RADIO KEYLINE MODIFICATION

SCOPE: This modification applies to all Sigtronics intercom (SPA-, SDB-, SCI-, Sport-) installations that will utilize both pilot and co-pilot transmit positions. See alternate solution if using pilot only transmit position.

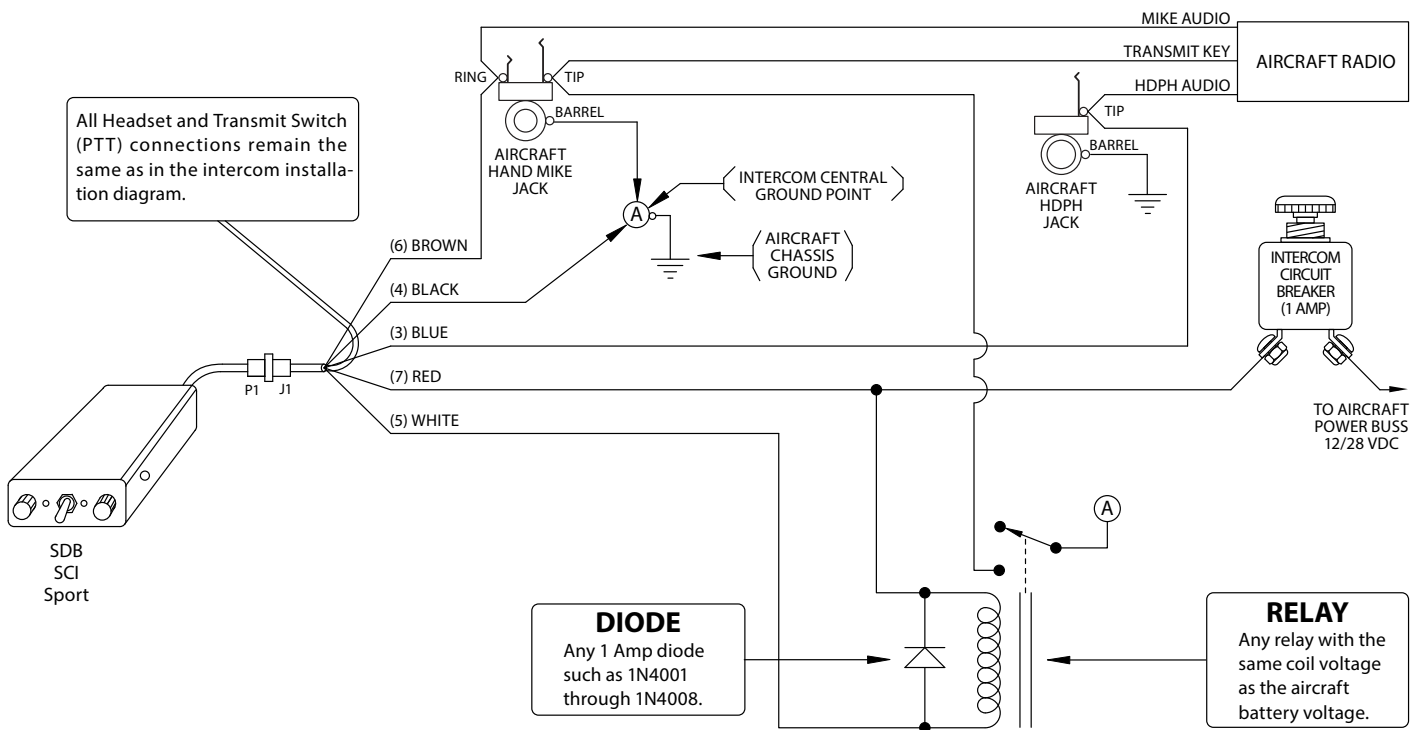
PROBLEM: The radio will not key up when either pilot or co-pilot PTT is pressed. This is due to the 0.7 volt diode drop within the intercom. Common installations affected usually involve KMA-20 audio panels or ICOM A220 radios.

VERIFICATION: Check to make sure all wiring and terminal connections are correct and unbroken. The radio will key up from the aircraft hand mike. Shorting the white wire (pin 5) to ground will key up the aircraft radio. The radio will not key from either PTT position. Shorting the white / red (pin 2) or the white / blue (pin 10) will not key the aircraft radio.

SOLUTION: A relay can be added to the installation that will eliminate the 0.7 volt diode drop. Follow the wiring diagram below.
